Addendum No. 01

Issued: **20 Feb. 2026**

Project Name: **SJSD Albert R. Lyman Middle School**

Project No.: 2023554.01

A3
SB102
ENLARGED FOOTING AND FOUNDATION PLAN - COUNSELING
SCALE: 1/4" = 1'-0"

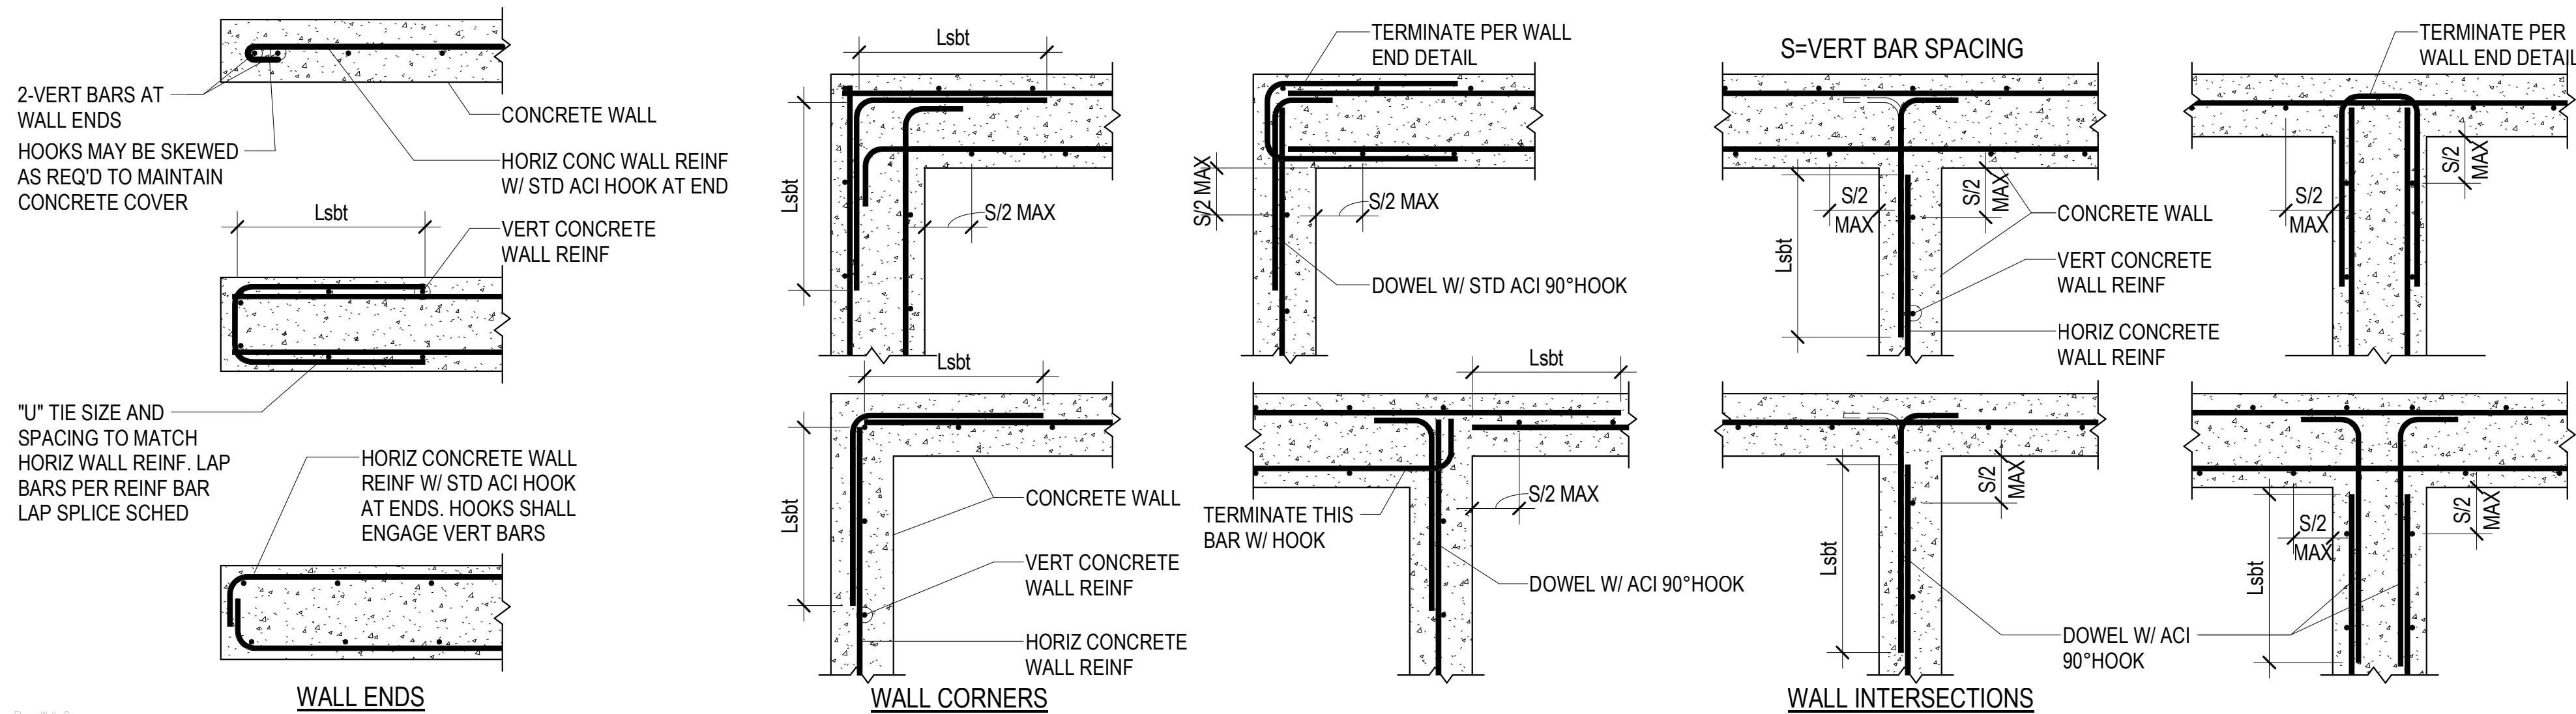
- S1.1 Sheet SB102 – Enlarged Footing and Foundation Plans:
1. No changes to the design. Shifted plan A3 for clarity.
- S1.2 Sheet SB103 – Enlarged Footing and Foundation Plans:
1. Removed opening in north-west wall of new reception area.
 2. Existing masonry wall on west side of new reception area is tagged as to be demolished.
 3. Steel columns for frame around new window in west wall have been removed and a single steel column with foundation is added aligned with the existing masonry wall.
- S1.3 Sheet SB601 –Concrete Schedules:
1. Added thickness to continuous footing type FC2.4.
- S1.4 Sheet SF103 – Enlarged Roof Framing Plans:

A4 MASONRY WALL ELEVATION
SCALE: 1/4" = 1'-0"

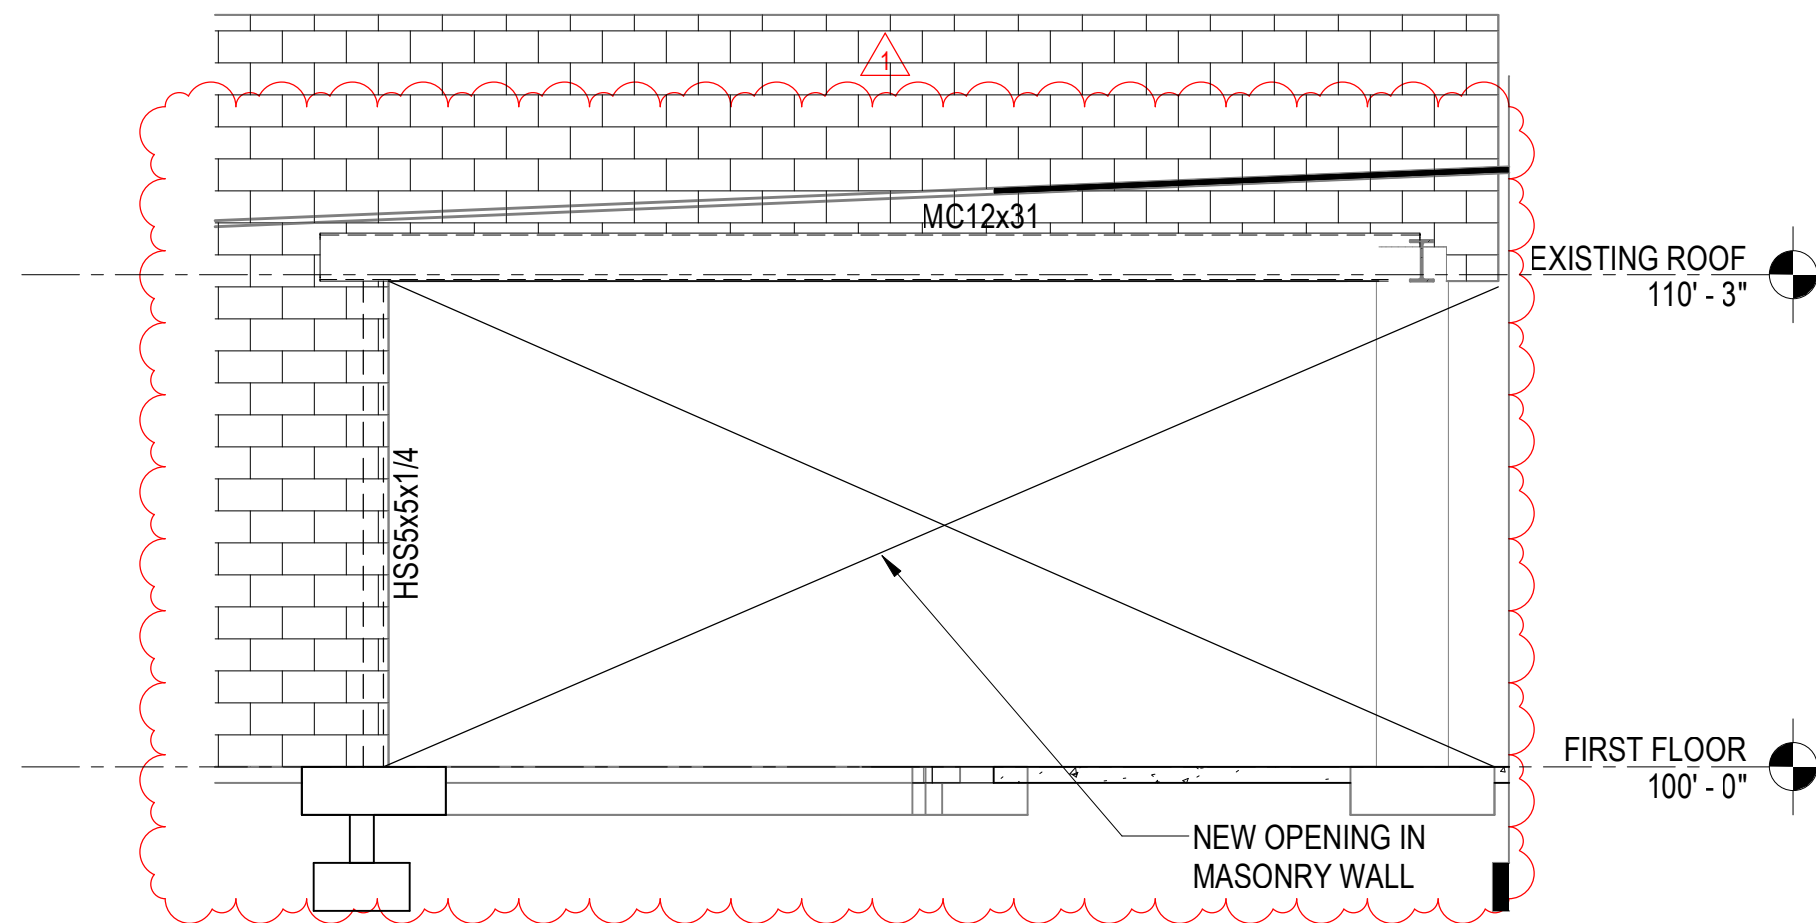
3. Elevation A4 – Expanded to show channels spanning from new steel column to existing concrete column.
- S1.6 Sheet SF511 – Typical Roof Framing Details:

C2 MASONRY WALL ELEVATION
SCALE: 1/4" = 1'-0"

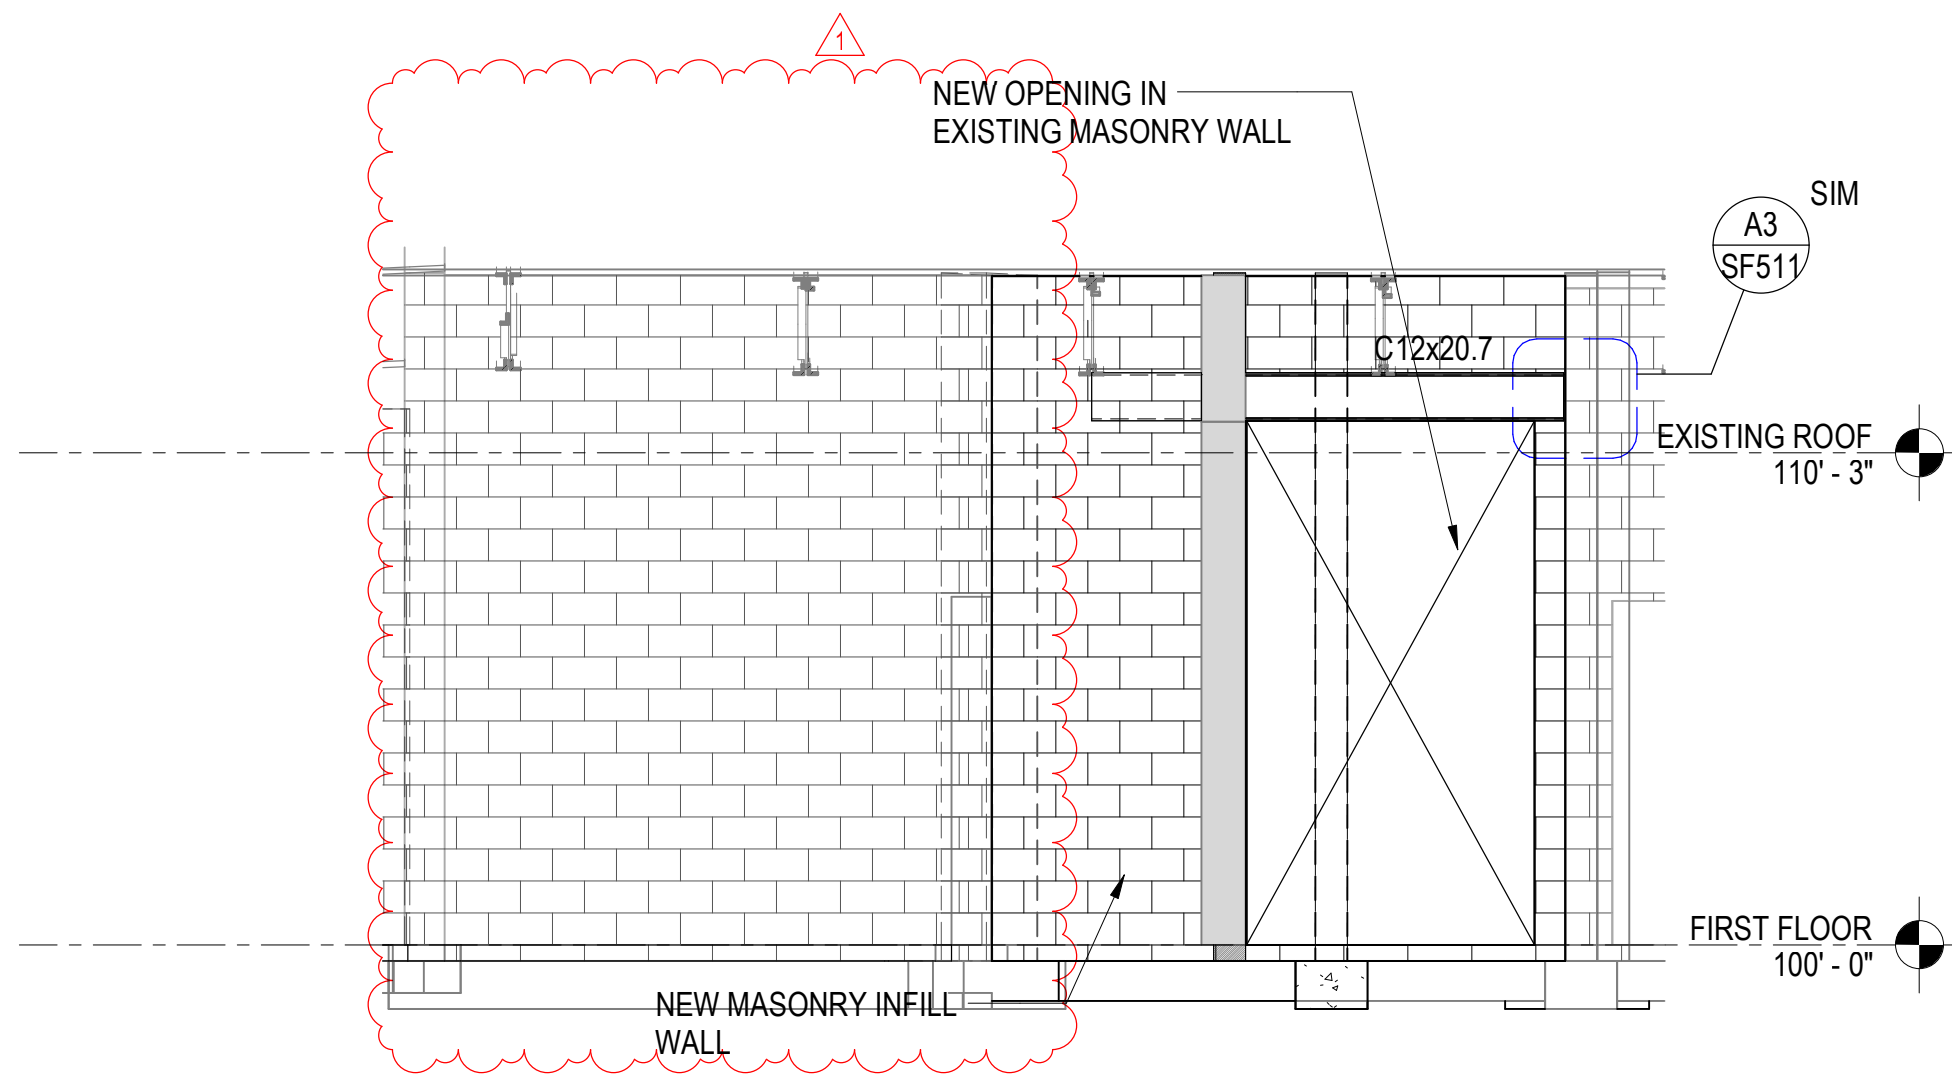
- S1.5 Sheet SF201 – Wall Elevations:
1. Structure adjusted to show framing more accurately for clarity.
 2. Elevation C2 – Left opening and associated channels are removed.

C3 TYPICAL STEEL BEAM BOTTOM FLANGE BRACE DETAIL
SF511 NO SCALE

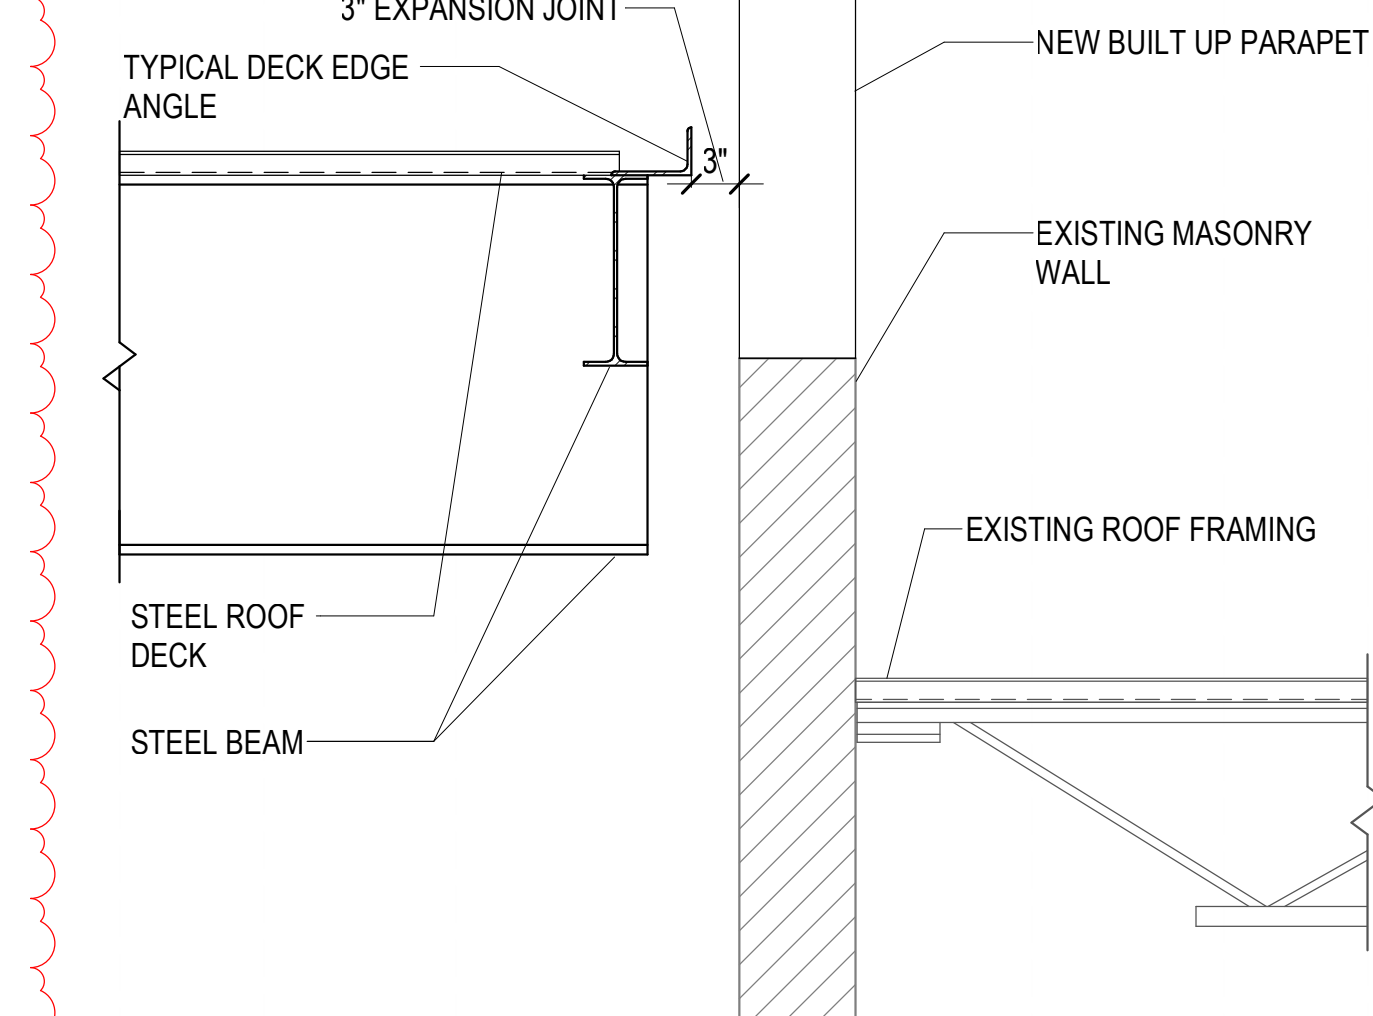
1. Added detail C3 for steel beam bottom flange bracing.
- S1.7 Sheet SF512 – Typical Roof Framing Details:
1. Added details C2 and C3 to show end connections for new sandwich channels on the west wall of new reception area.

D1 PARTIAL DEMO PLAN - ADMIN
SCALE: 1/4" = 1'-0"

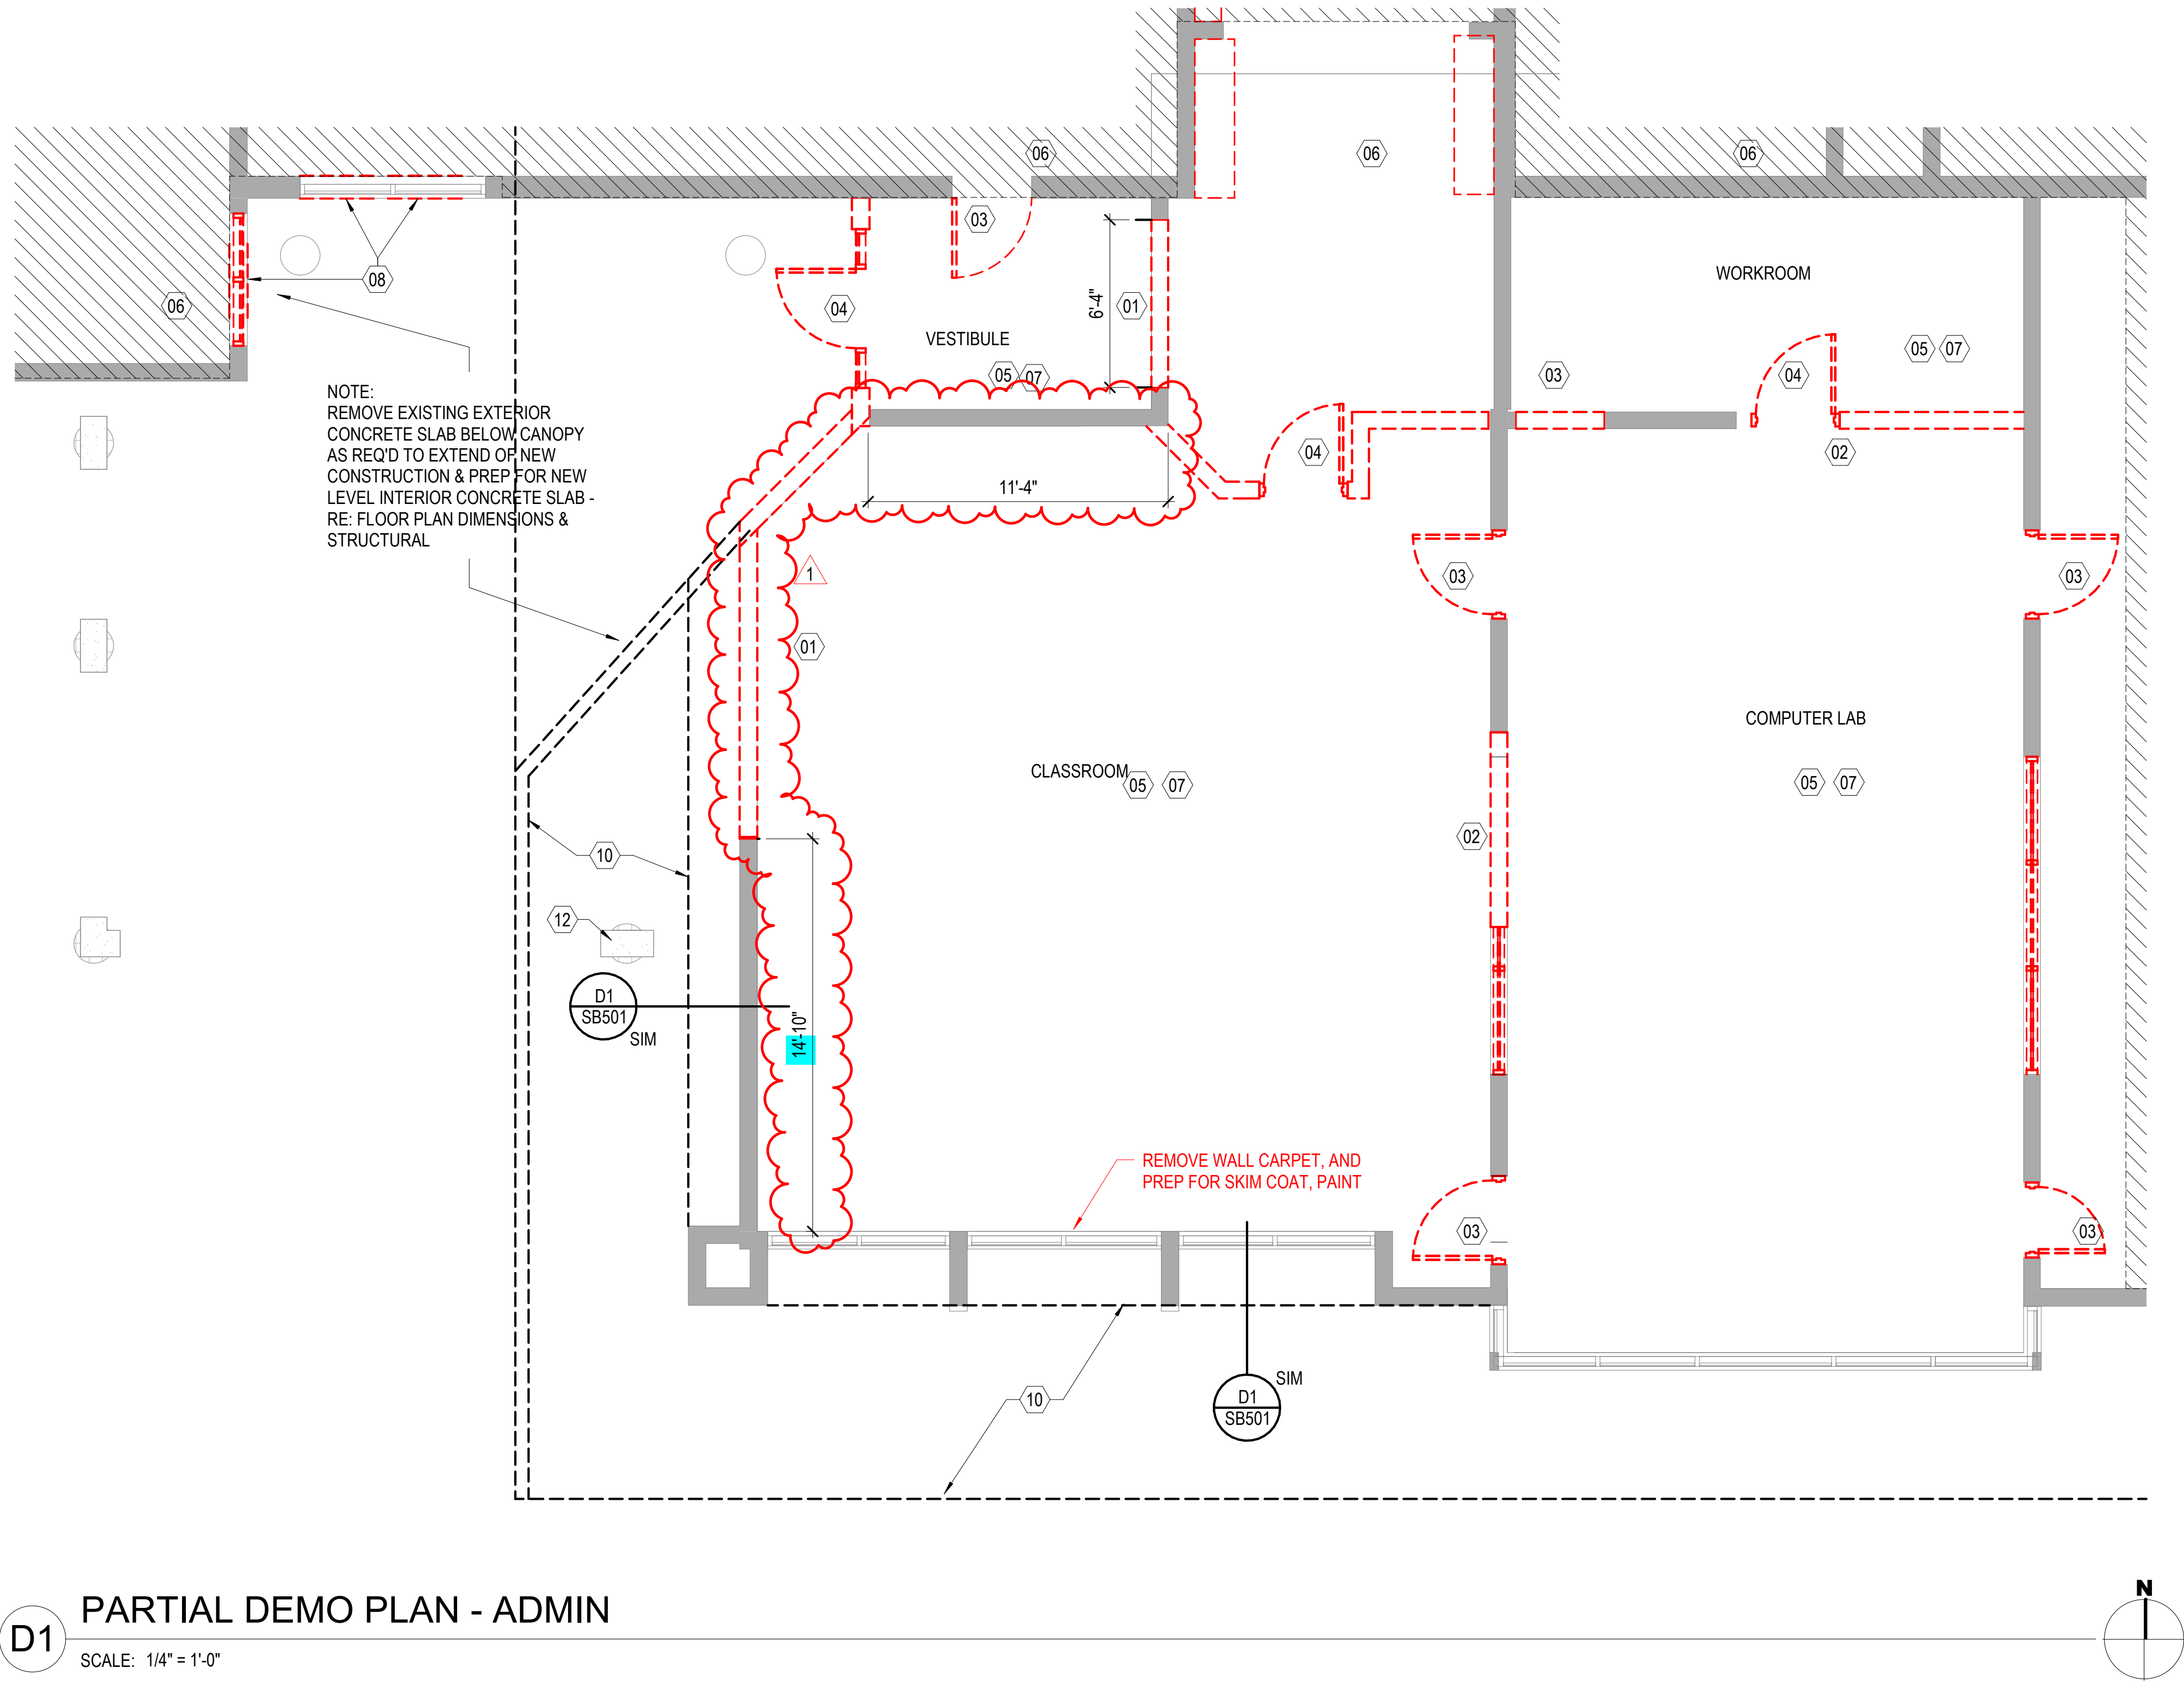
- A1.1 Sheet AD100 – Admin Demolition Plan
1. Updated extents of wall demolition to include more of West wall of exterior side classroom. Refer to structural drawings for demolition and supplementary wall bracing steel channels to be added to portion of wall above ceiling.

2. Removed scope of demolishing North wall to accommodate window.
- A1.2 Sheet A101 – Admin Partial Floor Plan
1. Reconfigured reception entry and added store front system at West and North walls of reception A102.
